PLANNING COMMISSION AGENDA

Public Hearing - Application by Opus Development Company, LLC for Administrative Subdivision, Rezoning and Site Plan Review.

To:	Kevin Shay, Planning	From:	Jason Quisberg, Engineering Lauren Pierce, Engineering
Project:	Opus – 17600 Territorial Rd	Date:	October 27, 2023

Preliminary Site Development Plans for Dayton Interchange Dayton, Minnesota Presented by: Opus Development

SHEET NUMBER: C3.01

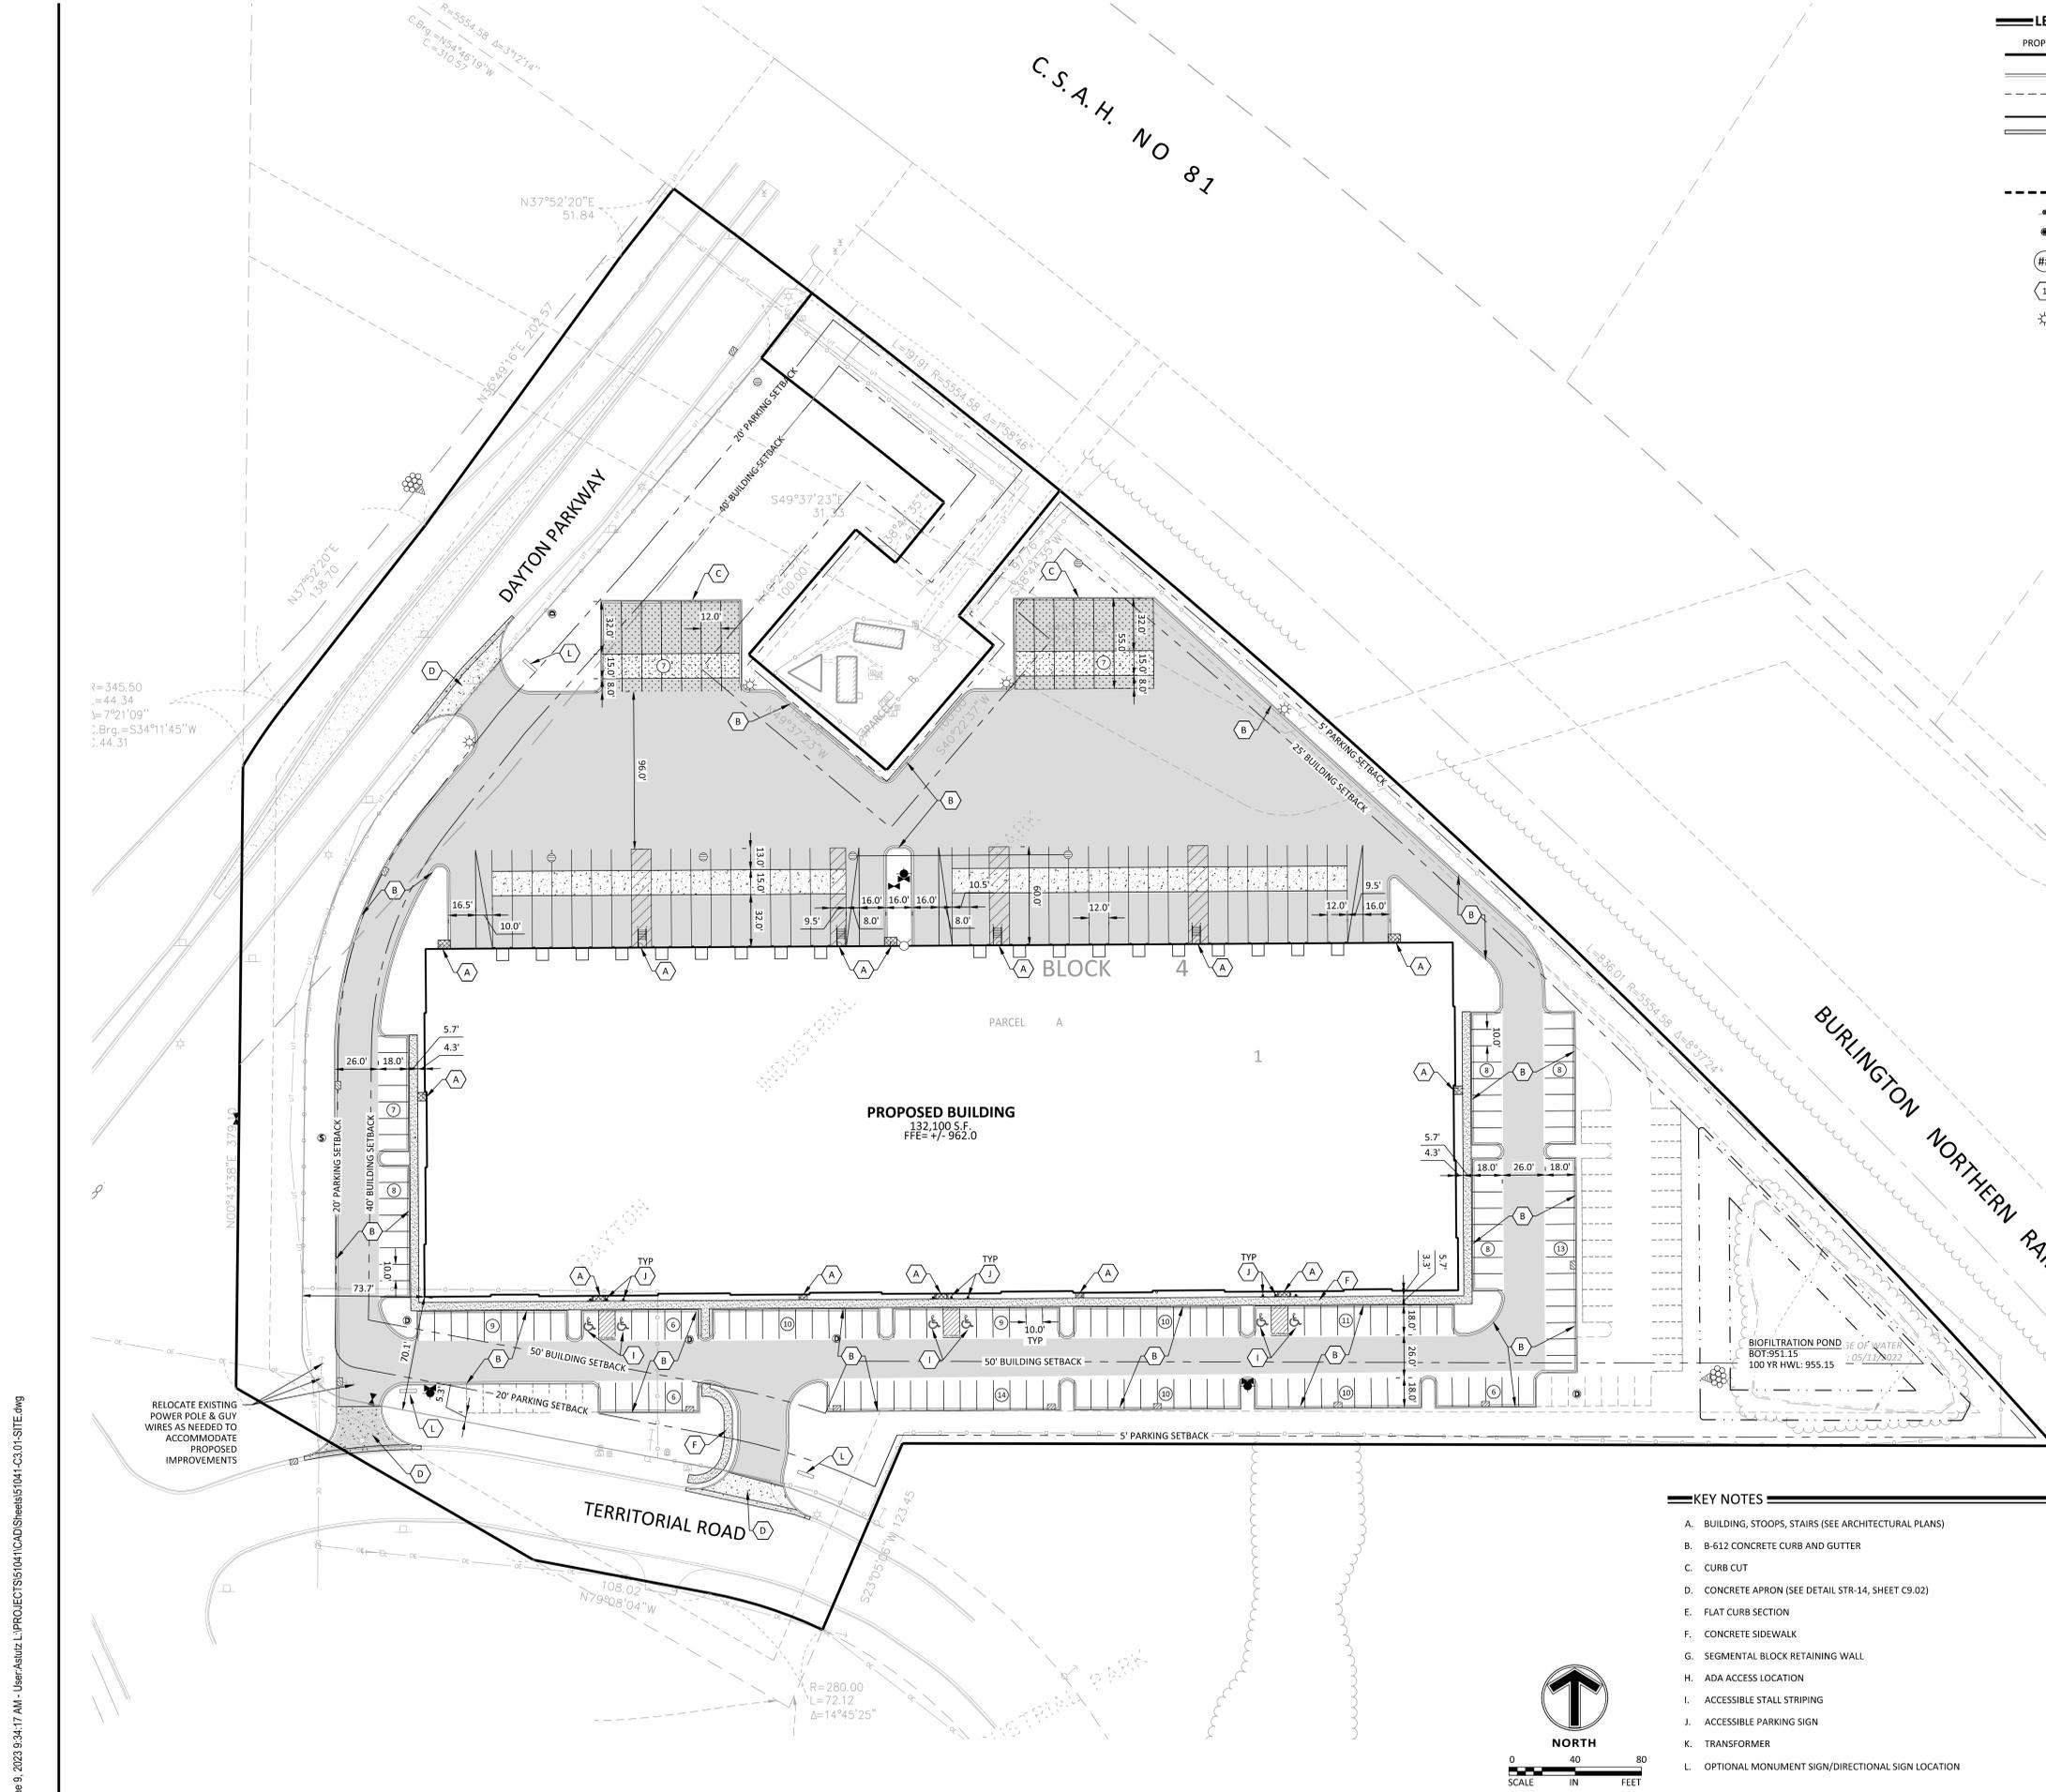
The plans show three access drives to Parcel A; two access drives are proposed from Territorial Road to the south and one access drive is proposed from Dayton Parkway to the northwest. The location of driveways are designed to reduce the cross traffic between truck and auto traffic in and out of the site. However, the City Engineer has indicated that access to the site will be limited to Territorial Road and access from Dayton Parkway will not be permitted. While a single access from Territorial Road is preferred there is a benefit to separating vehicle and semi-truck traffic into the site. A condition has been included to remove Dayton Parkway access and increase the spacing between the two Territorial Road access drives to the maximum extent possible.

Based on the floor area of the building allotted to warehousing or office uses, the code requires a total 153 parking spaces; the warehouse use requires 59 parking spaces and the office use requires 66 spaces. Plans show 153 parking spaces are provided in excess of the minimum number required. Curb and gutter are provided along the perimeter of the parking lot, semi-loading, semi-storage and access drives.

The applicant has also provided proof of parking for an additional 36 spaces, demonstrating the ability to provide more on-site parking if the proposed parking is not sufficient. However, approximately four stalls would be lost in order to provide access to proof of parking in the southeast corner of the site. The proof of parking provided southwest of the proposed building is situated within the 20 foot parking setback. Staff has included a condition that requires plans shall be revised to remove proof of parking located within the parking setbacks.

Section 1001.19 of the Zoning Ordinance provides standards for off-street loading and unloading areas. Plans show 19 semi-trailer loading areas along the north side of the proposed building. As noted earlier in the staff report, access to the semi-loading and storage area must

- c. Remove future proof-of-parking from within the required parking setback along Territorial Road.
3. The applicant's contractor shall obtain all required approvals and permits from the City, County and state prior to commencement of project construction.

SHEET TITLE
UTILITY PLAN

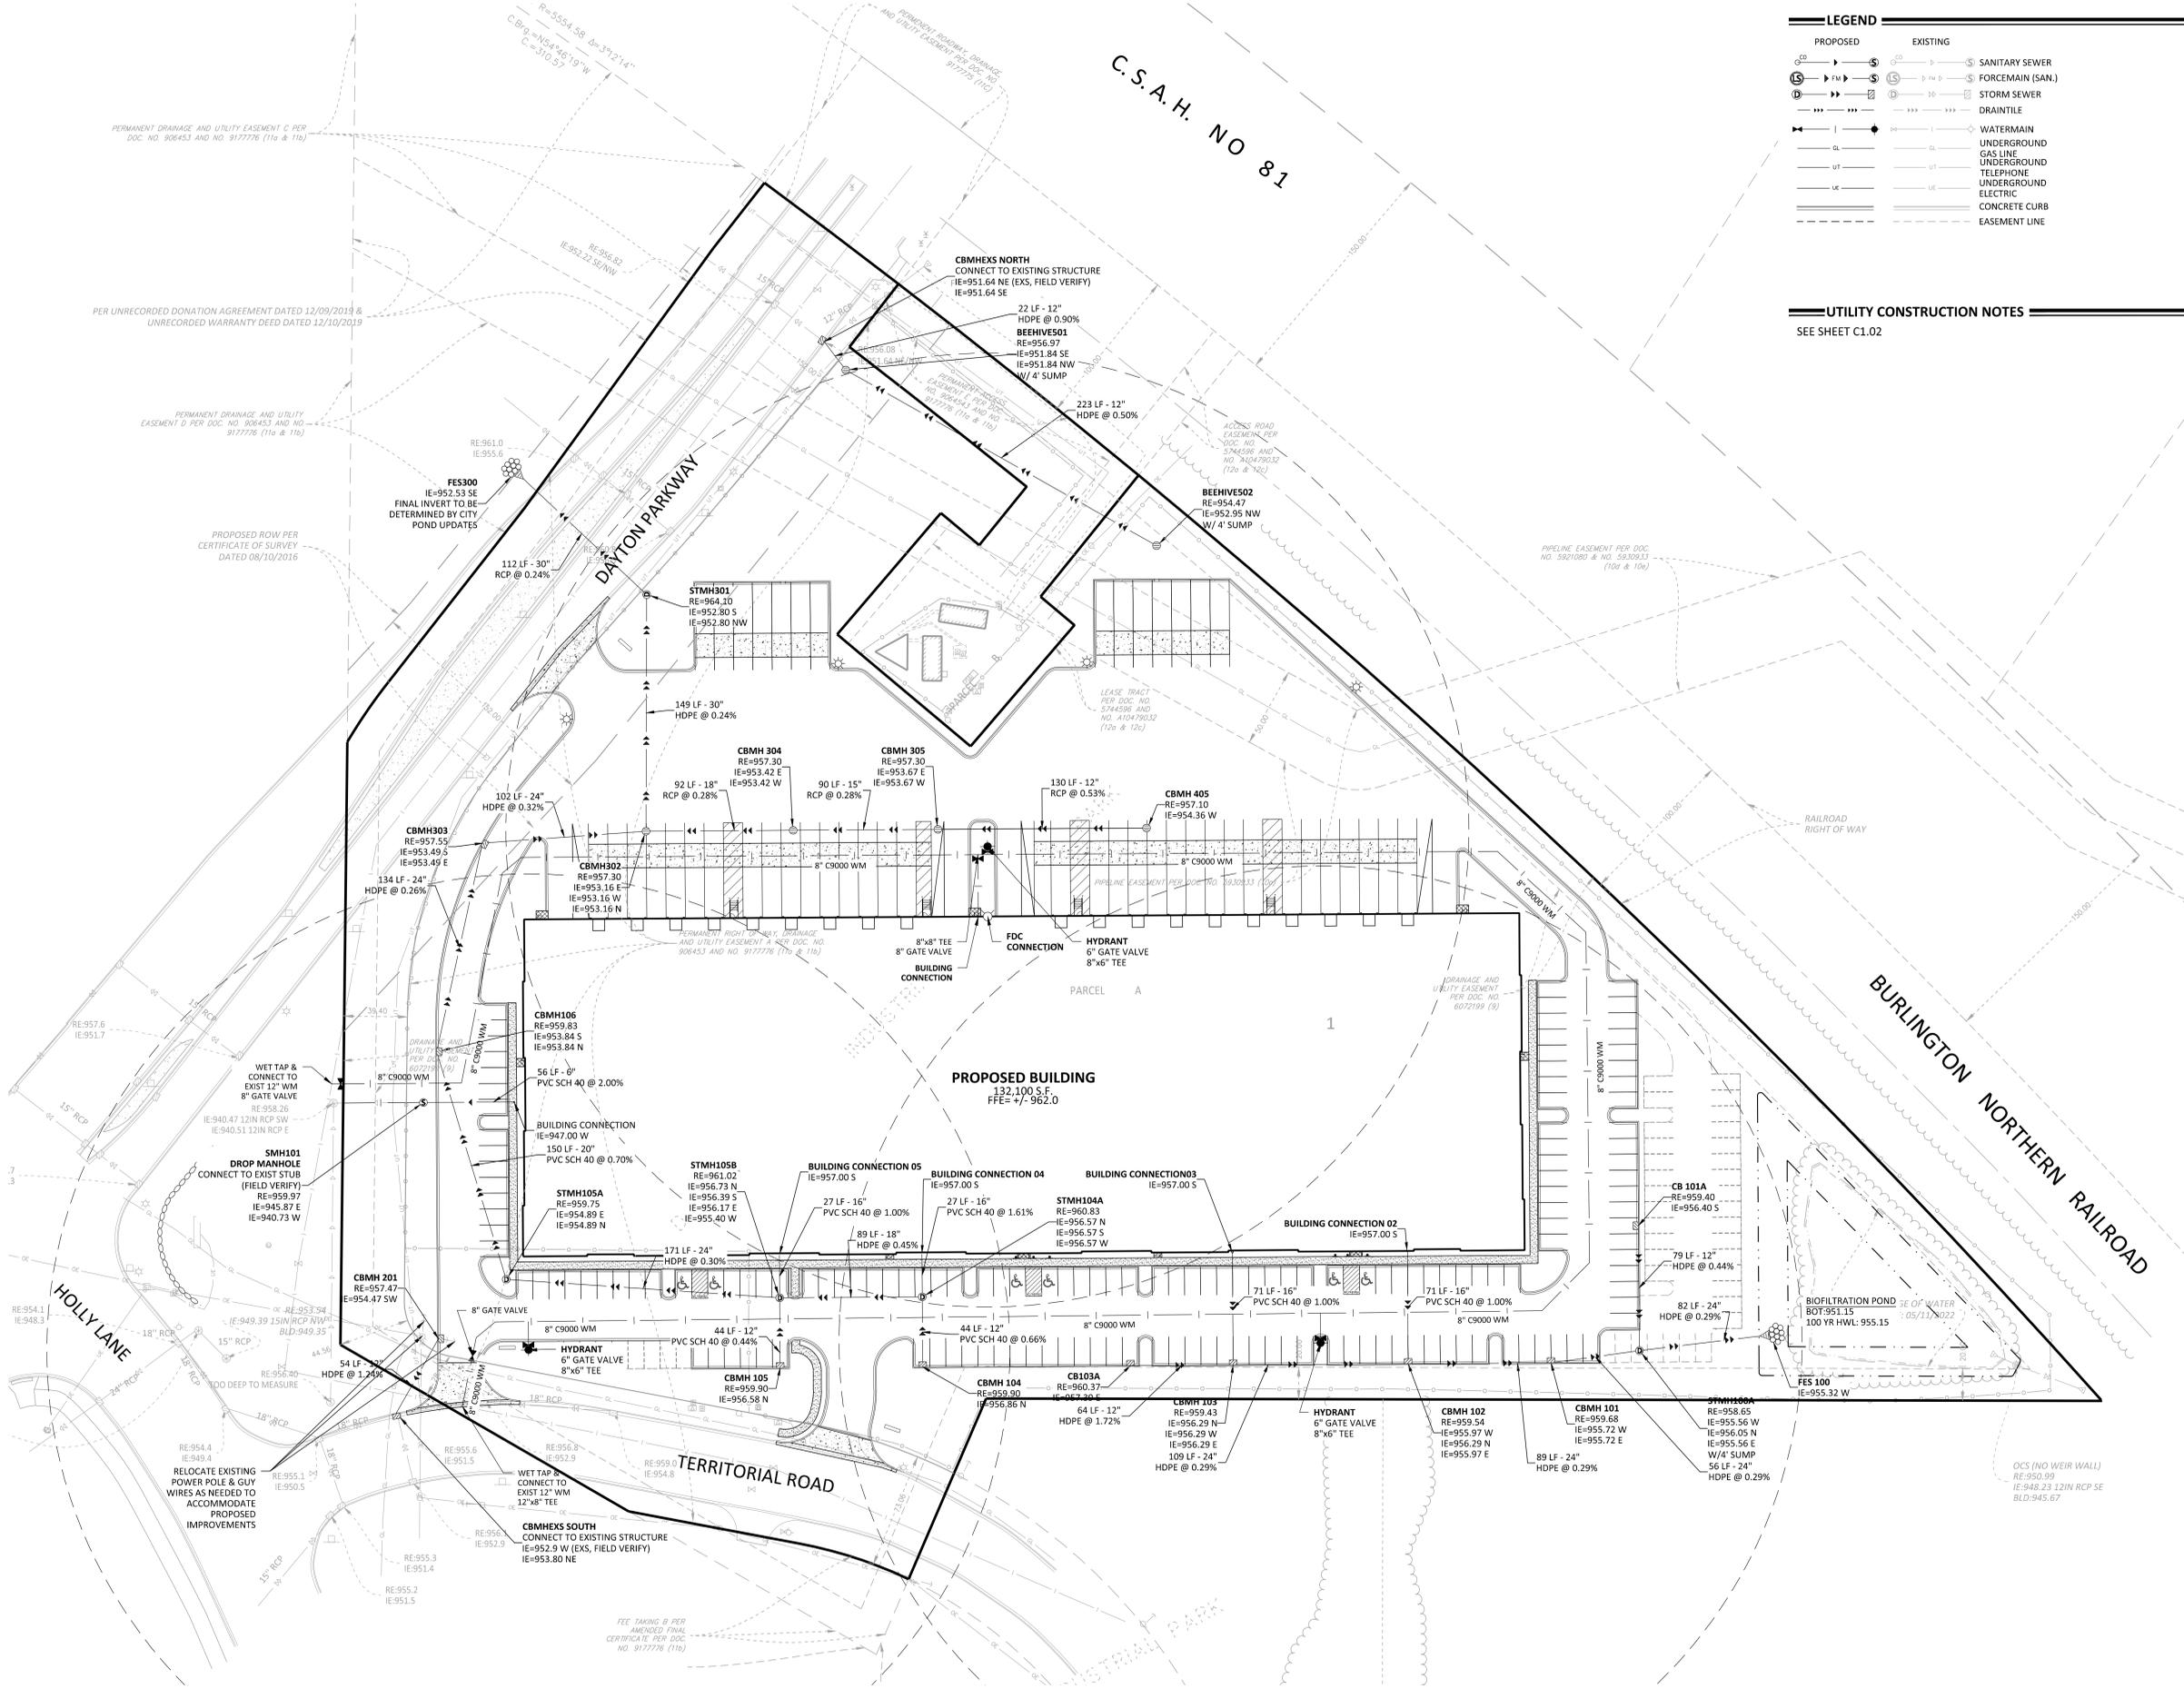
- o Another crossing (30”) is proposed to be drilled under Dayton Parkway, and this crossing would take most of the water that is sent from the Opus site to the south pond across Dayton Parkway. Elevation and location of this crossing will need to be considered in further detail (and potentially adjusted based on pond information, conflicts within the roadway, street section on Dayton Parkway, and other factors), but it appears that a drilled crossing should be feasible.

3. It appears feasible to provide stormwater treatment for the site on the parcel across Dayton Parkway by expanding the existing ponding system. Detailed design of this expansion will be necessary, and it must be determined who will perform that design and how compensation will be provided.
